379 Middle Tpk

Existing Plot Plan

APPROVED
 PARKING AREA SITE PLAN
 FEB 28 2012
 TOWN OF MANSFIELD
 HOUSING INSPECTION

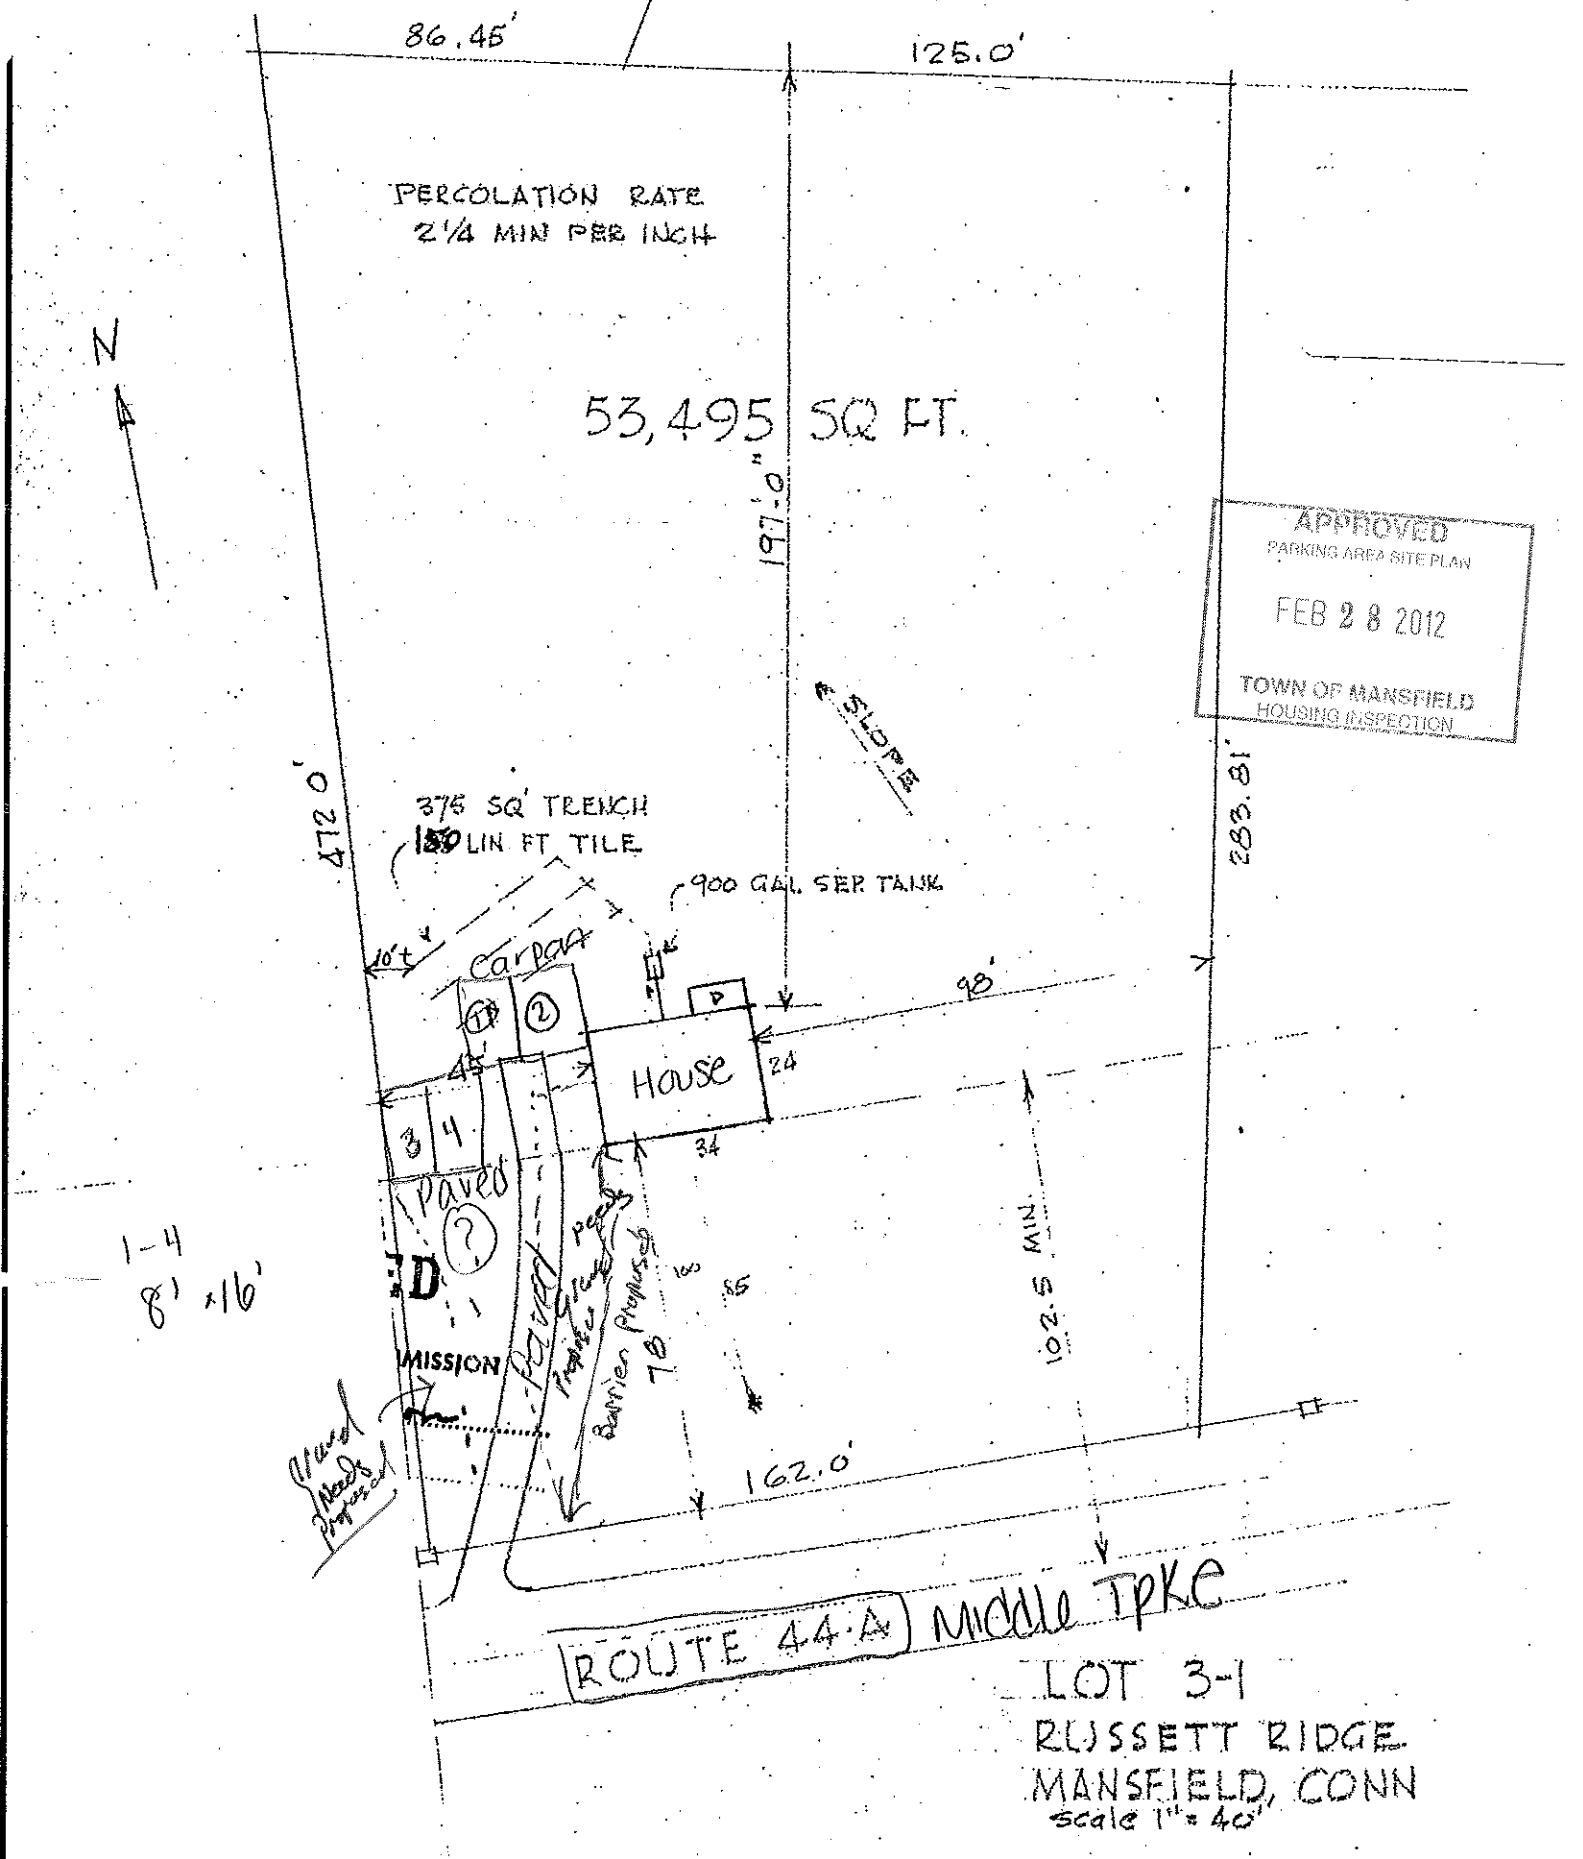
PROPOSED BARRIERS MUST BE INSTALLED AND APPROVED BY 6/1/12. PLEASE SCHEDULE AN INSPECTION WHEN WORK IS COMPLETE.
